CNL-15-128

Sequoyah Nuclear Plant, Units 1 and 2
Facility Operating License Nos. DPR-77 and DPR-79
NRC Docket Nos. 50-327 and 50-328

Subject: **Sequoyah Nuclear Plants, Units 1 and 2 Technical Specifications
Conversion to NUREG-1431, Rev. 4.0 (SQN-TS-11-10) - Supplement 2**

**Sequoyah Nuclear Plant, Units 1 and 2 Technical Specifications Conversion to
NUREG-1431, Rev. 4.0 (SQN-TS-11-10) - Revision 1**

FIGURE 3.4-1
DOSE EQUIVALENT I-131 Primary Coolant Specific Activity Limit
Versus
Percent of RATED THERMAL POWER with the Primary Coolant
Specific
Activity > 0.35 μCi/gram Dose Equivalent I-131

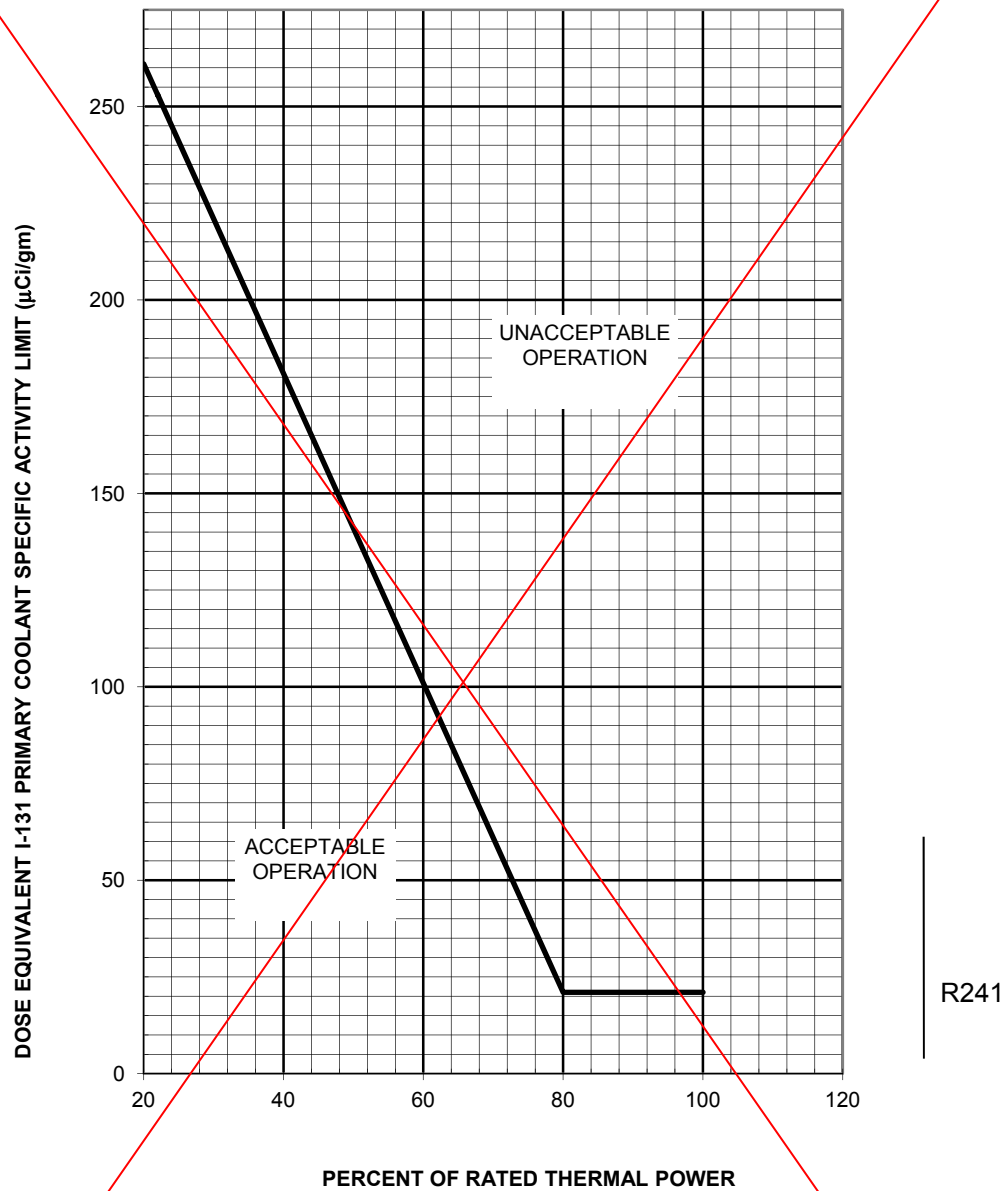
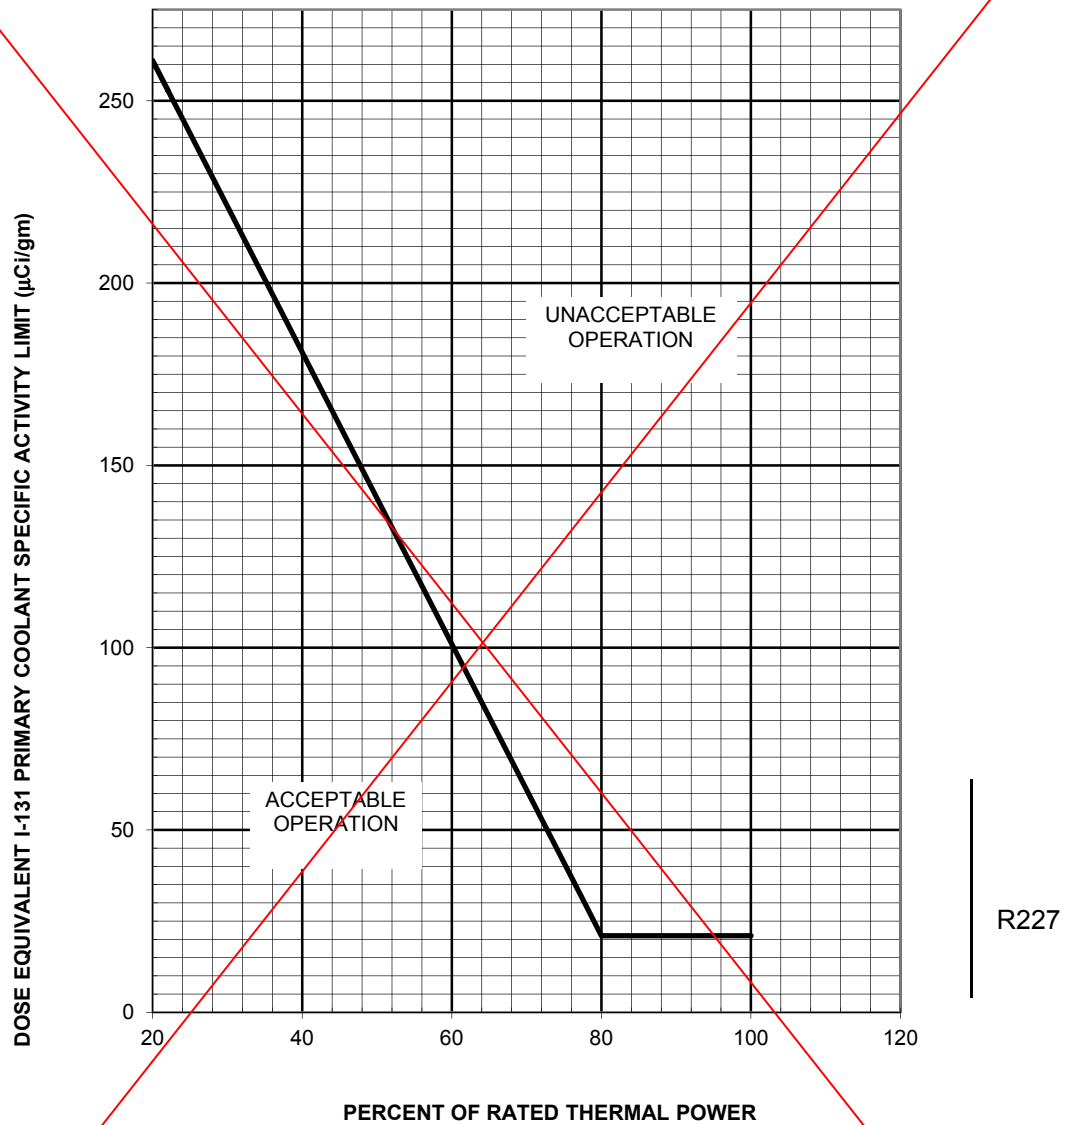
a. With ~~the specific activity of the primary coolant greater than 0.35 microcuries/gram~~
DOSE EQUIVALENT I-131* for more than 48 hours during one continuous time
interval or ~~exceeding the limit line shown on Figure 3.4-1~~, be in at least HOT
STANDBY ~~with T_{avg} less than 500°F~~ within 6 hours. LCO 3.0.4.c is applicable.

a. With ~~the specific activity of the primary coolant greater than 0.35 microcurie per gram~~ DOSE EQUIVALENT I-131 ~~for more than 48 hours during one continuous time interval or exceeding the limit line shown on Figure 3.4-1, be in at least HOT STANDBY with T_{avg} less than 500°F within 6 hours.~~ LCO 3.0.4.c is applicable.

Figure 3.5.5-1 (page 1 of 1)
Seal Injection Flow Limits

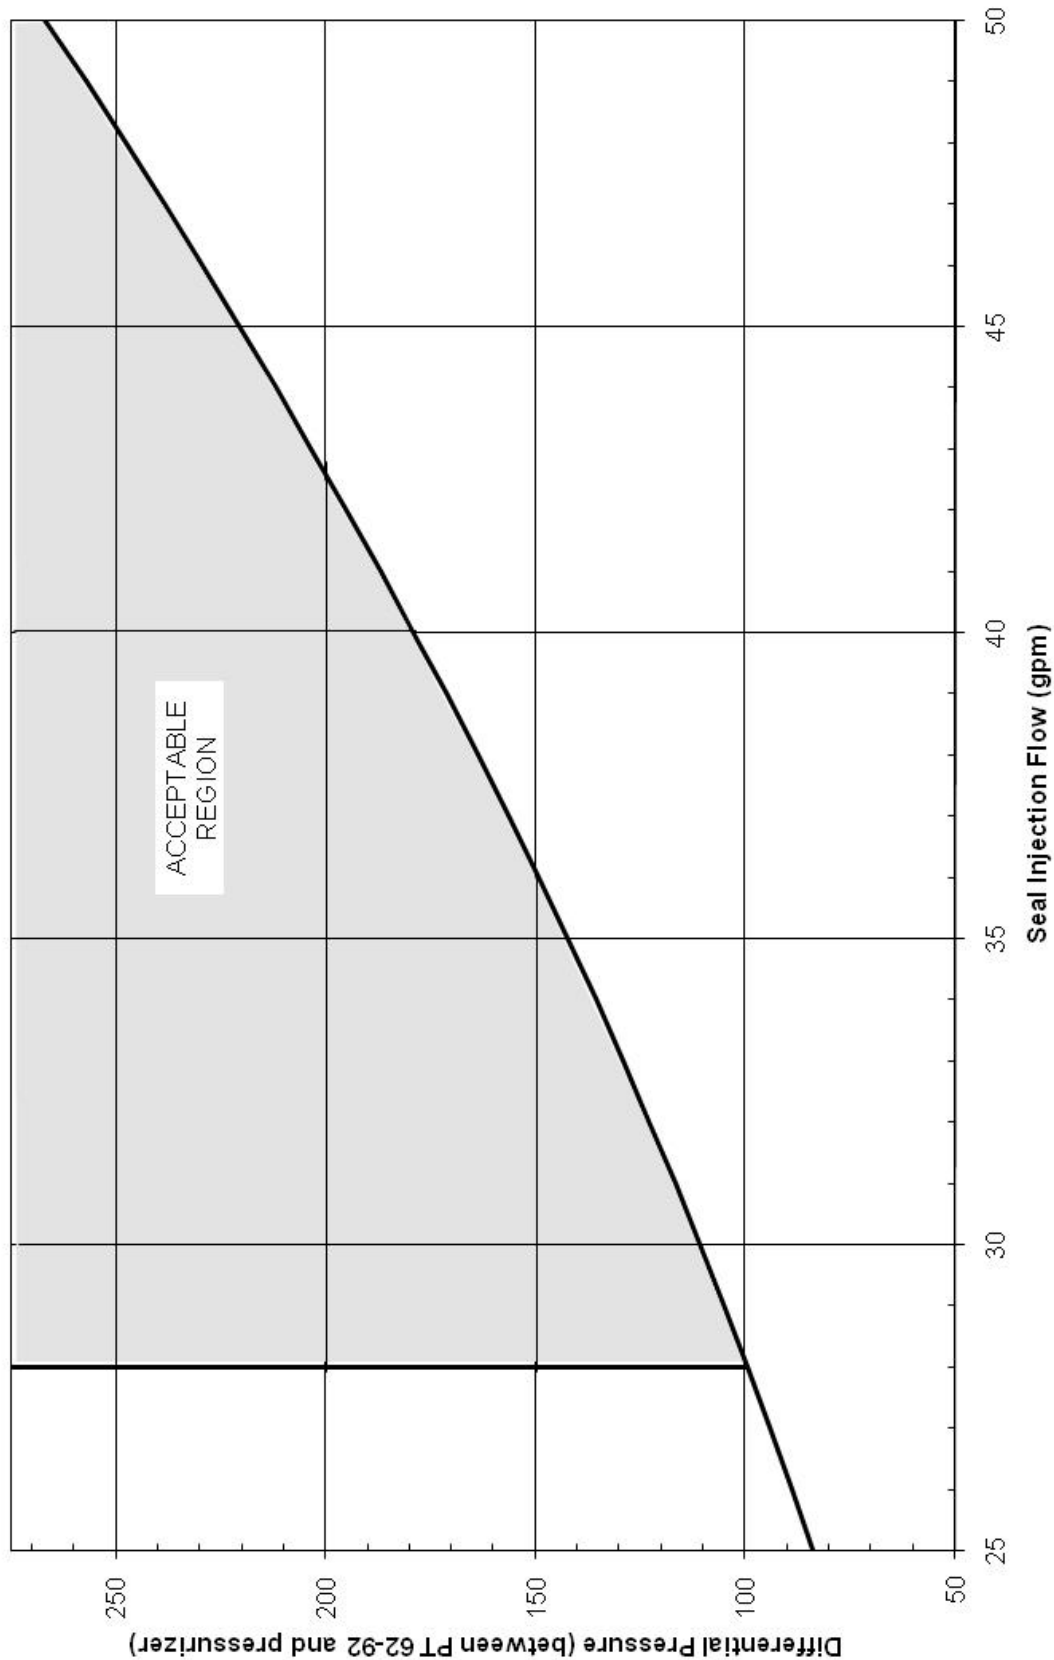
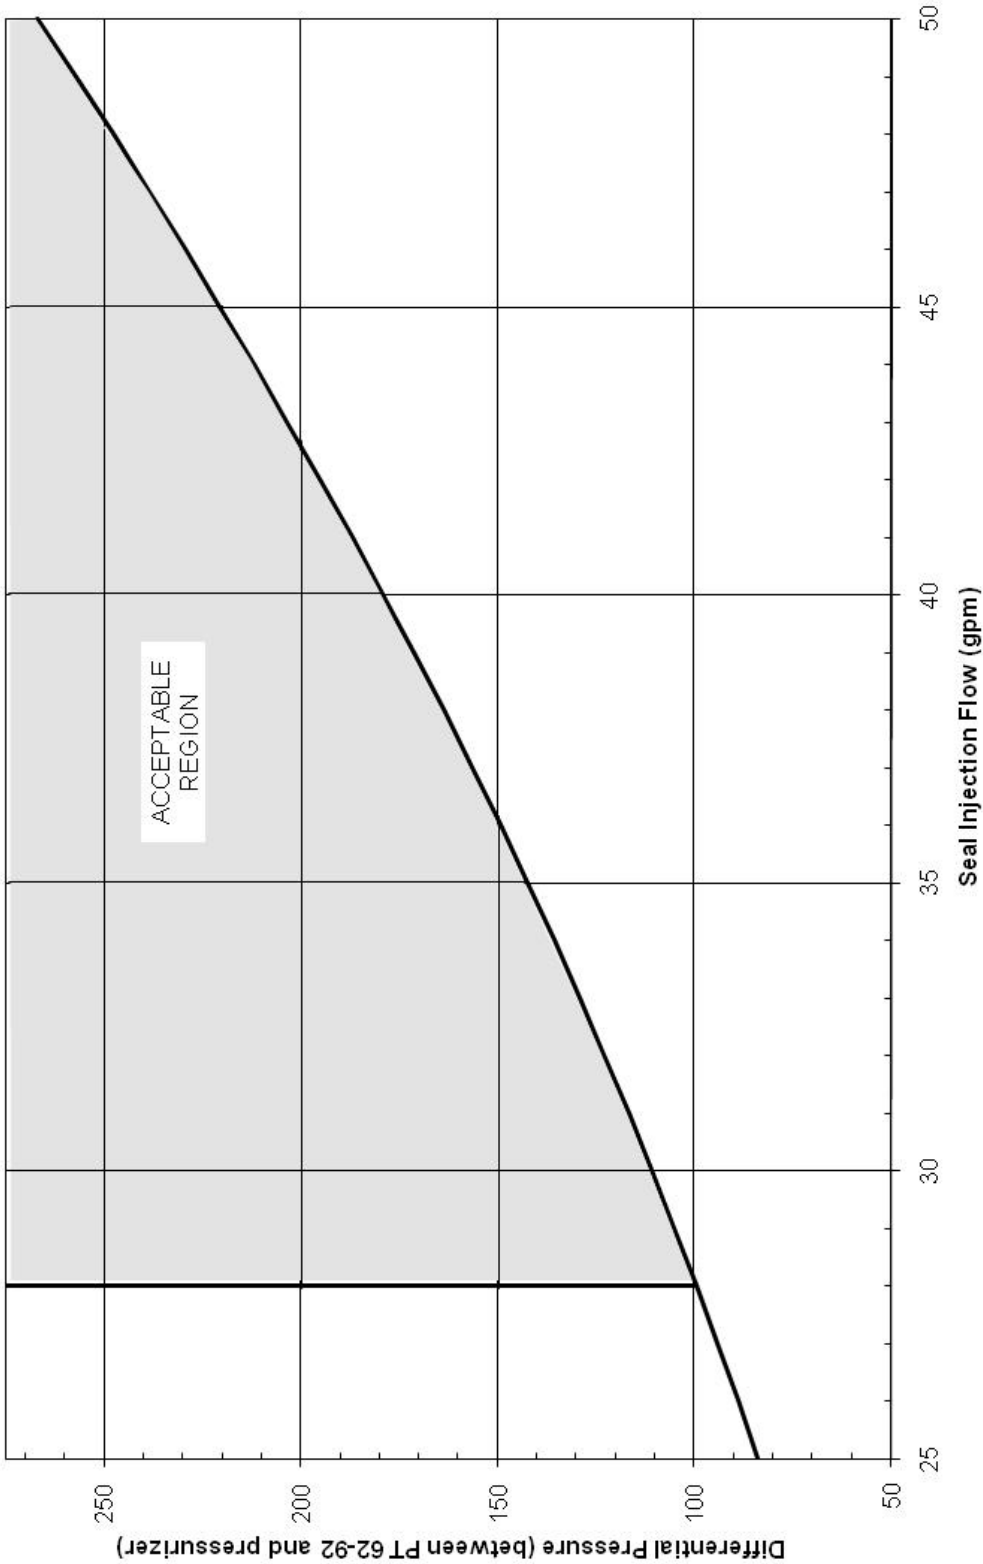
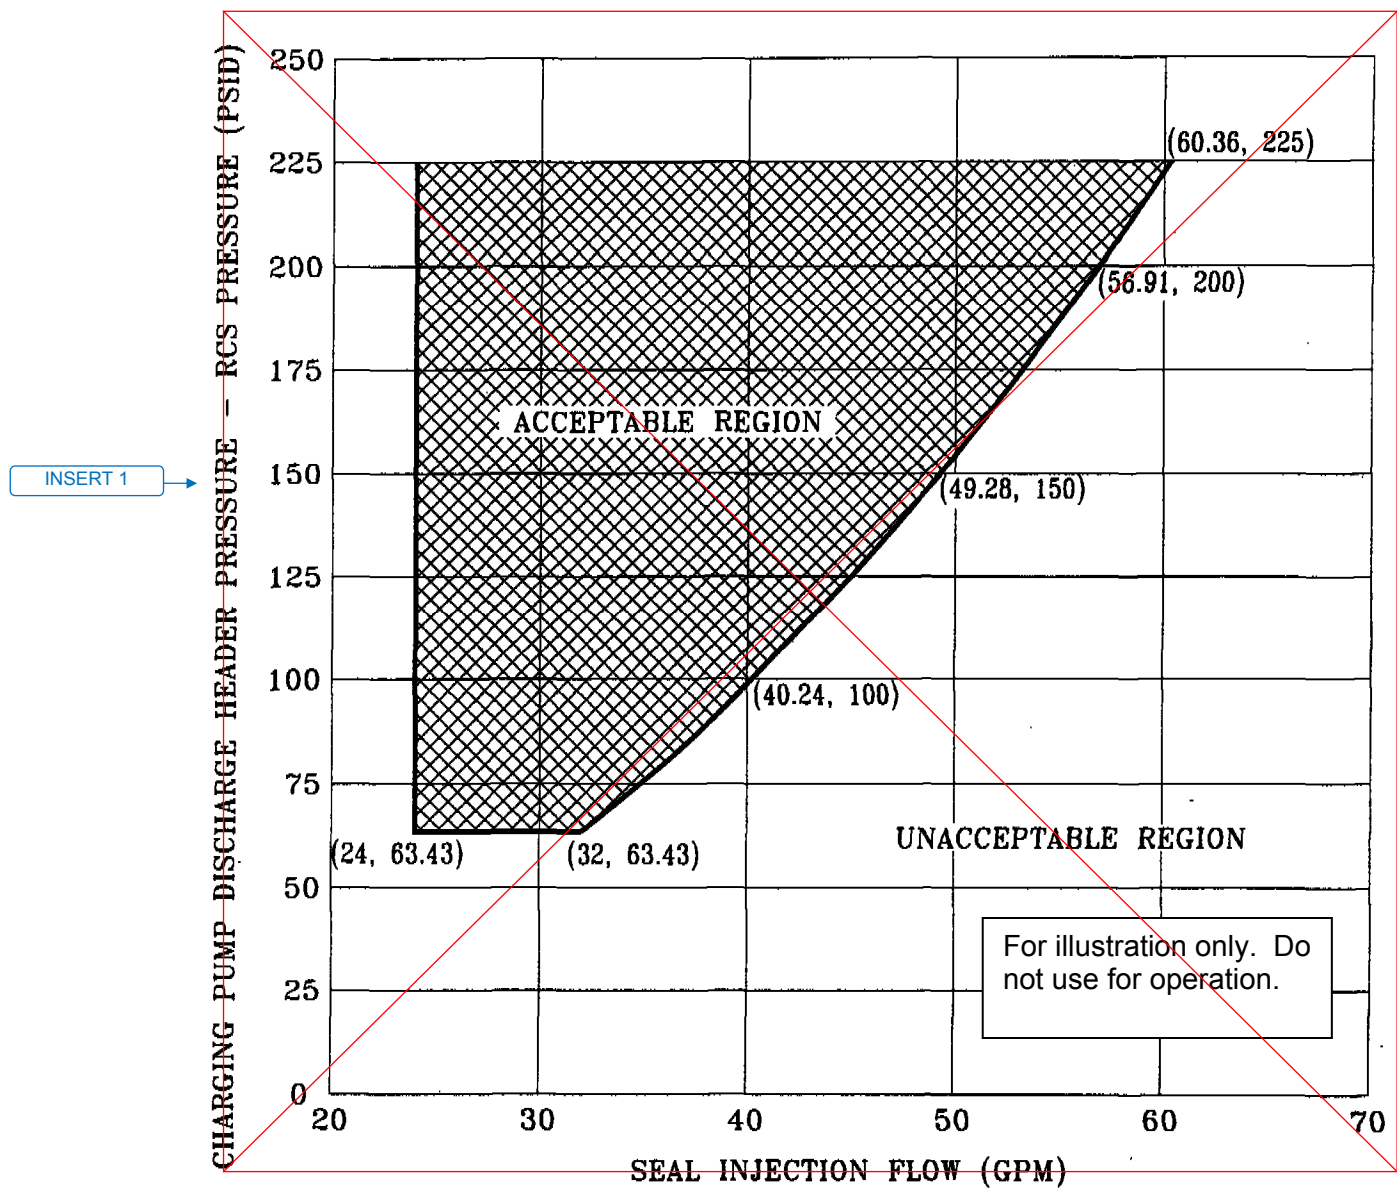
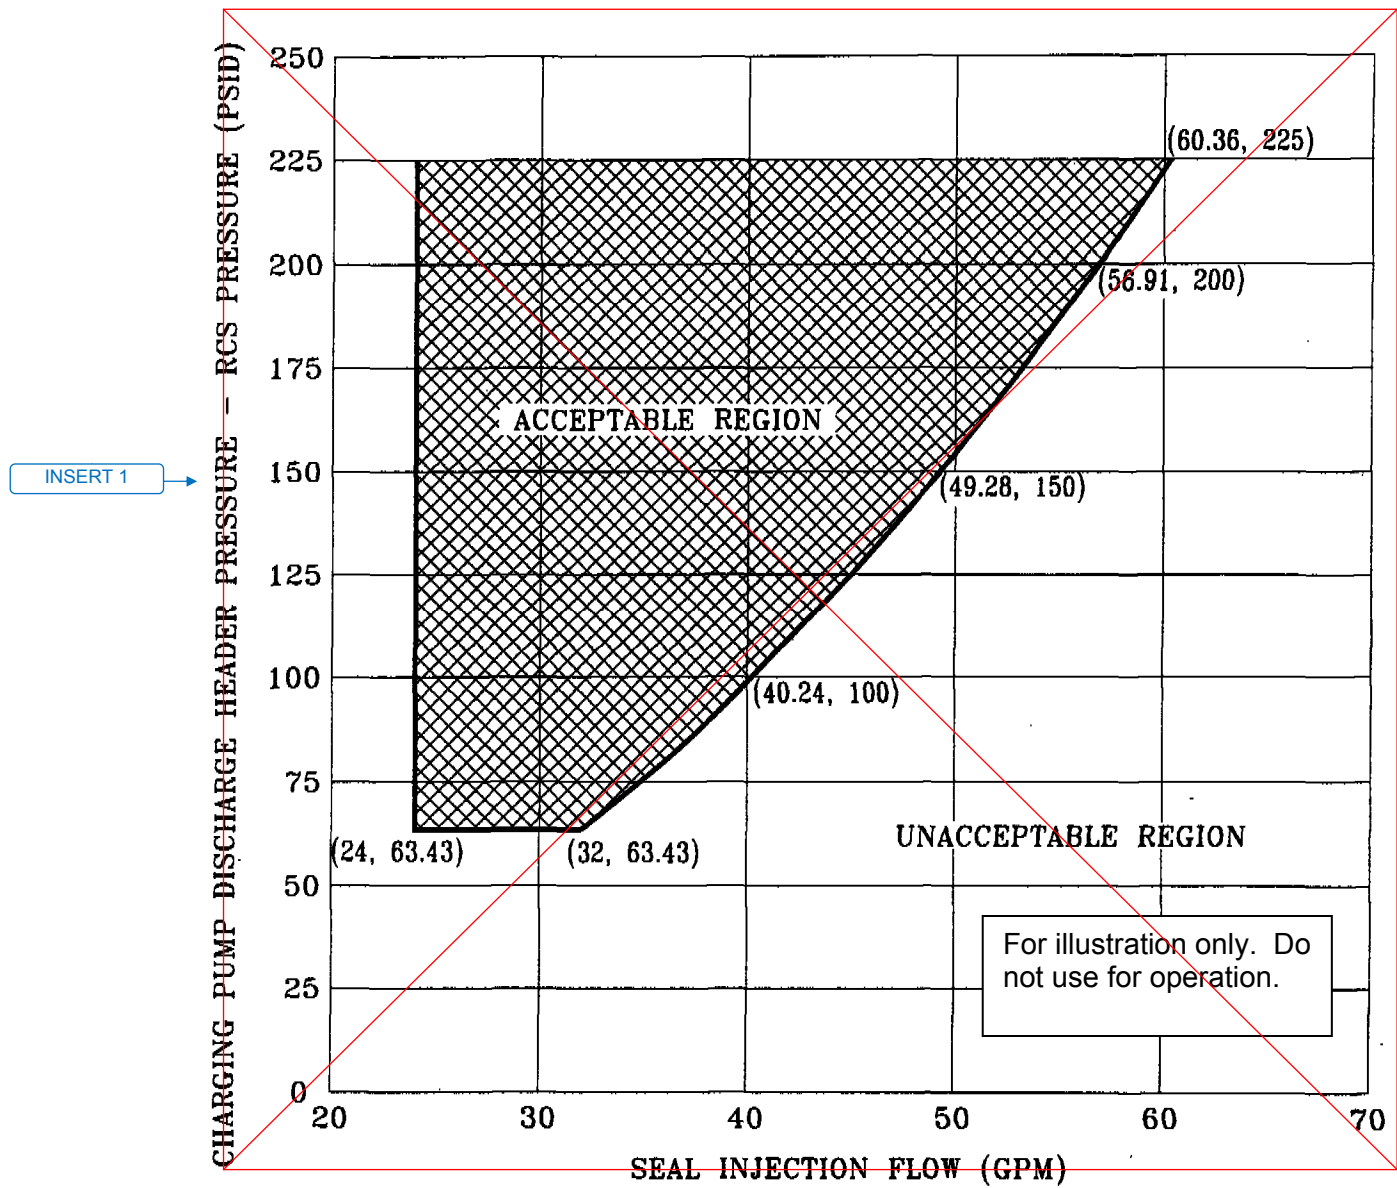
LCO 3.5.5 3.5.6 Reactor coolant pump seal injection flow shall be within the limits of Figure 3.5.6-1.

- LA01 (*Type 5 – Removal of SR Frequency to the Surveillance Frequency Control Program*) CTS 4.5.6 requires, in part, verifying manual seal injection throttle valve are adjusted to give a flow within the limits of Figure 3.5.6-1 every 31 days. ITS SR 3.5.5.1 requires a similar Surveillance and specifies a periodic Frequency of, "In accordance with the Surveillance Frequency Control Program." This changes the CTS by moving the specified Frequency for this SR and associated Bases to the Surveillance Frequency Control Program.

LCO 3.5.5 Reactor coolant pump seal injection flow ~~[resistance]~~ shall be ~~[≤ [40] gpm with [centrifugal charging pump discharge header] pressure ≥ [2480] psig and the [charging flow] control valve full open or ≥ [0.2117] ft/gpm² or~~ within the limits of Figure 3.5.5-1.
